SEWAGE DISPOSAL SYSTEM

HOWARD COUNTY HEALTH DEPARTMENT
BUREAU OF ENVIRONMENTAL HEALTH
410-313-2640

P 515030-A
A 511463C
ISSUE DATE 4/6/2001
APPROVAL DATE 4/18/01

DIVISION Avery Property LOT NUMBER 2 ADDRESS 14361 Frederick Road

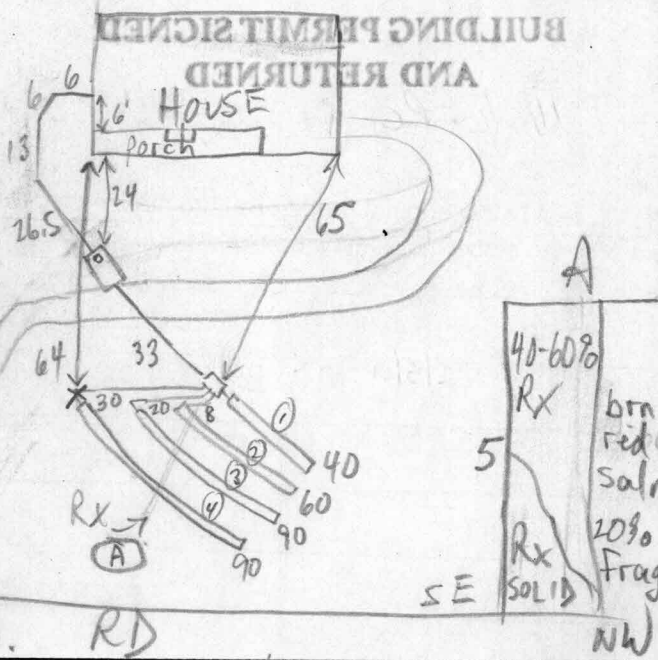
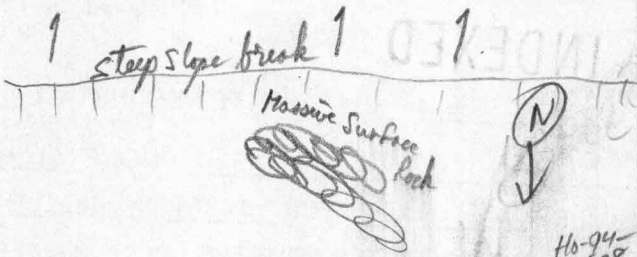
INSPECTION COMMENTS: 4/10/01 VEIN OF 40-60% RX THRU SOME TRENCHES, WORST IN LAST TRENCH; OK TO COVER, BUT ISSUE OF ROCK TO BE REVISITED (MR)

4/11/01 VIA T/C, REQUESTED ALTERATION TO AVOID RX, FLOCK AGREED (MR)

Note: per MR There is a rock ridge as shown above thru system. This is most severe in Trench # 4 which has a 15-20ft section of Trench in the Fractured, hard gneiss rock. Rather than reexcavate & bridge this bad portion, the entire last trench was abandoned & disconnected. IF needed for future repair this Trench could be reopened and repaired to get 50-60 LF of usable Trench.

piping to last trench was disconnected & section removed, rx to be filled with dirt. P/P 4/18/01
